Access Compliance Report Public Rights-of-Way (Pedestrian Signals)

Main Street: **S_BROOKHURST_ST** Cross Street: **ORANGE_AVE** Location: **SW**

ADA ID: **SGRK210927121432** Signal Type: **One Push Button-Non APS** Overall Compliance: **No** Severity Scores: **BTN 1: 55** **BTN 2: N/A** **No BTN: N/A**

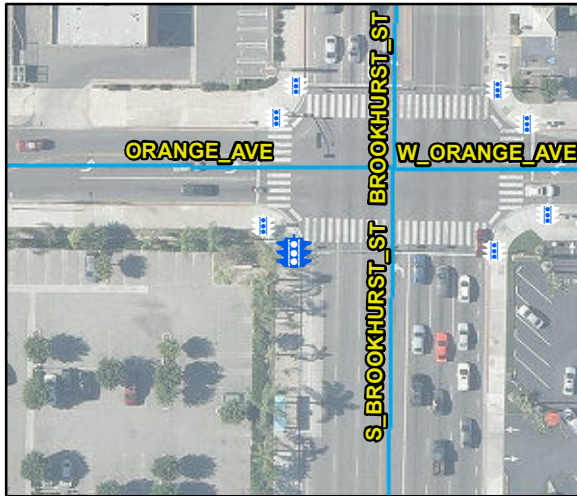
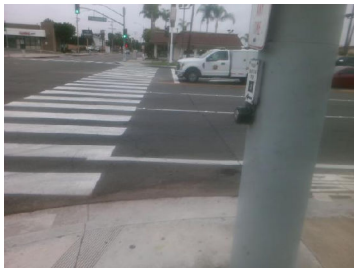
Possible Solutions: Replace Signal Push Button With APS Button. Remove & Relocate Sign. Adjust Signal Button Height.

OC Std/PROW: **MUTCD 4e.08, R404.2, R406**
